Appl. No. 09/592,950

REMARKS / ARGUMENTS

VERSION WITH MARKINGS TO SHOW CHANGES MADE

**FIG. 1**

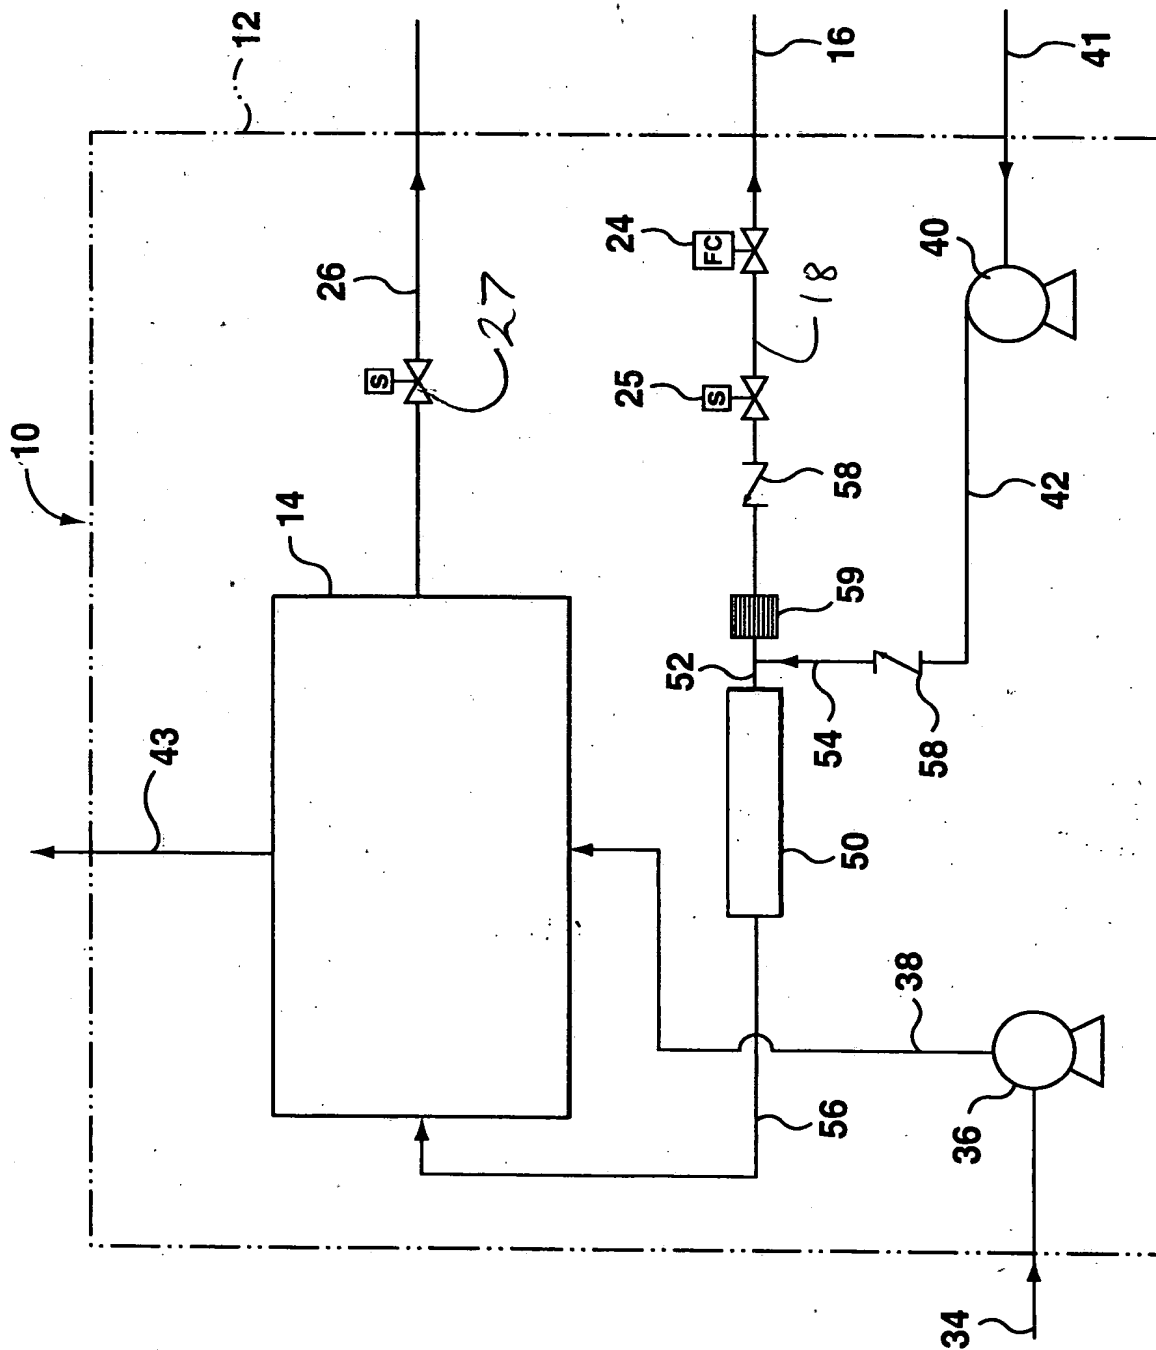
In response to the drawing objections, an amended Figure 1 is enclosed, including the reference numerals 18, 27, together with a set of formal drawings including this amendment. A description of Figure 3c has been added on page 8.
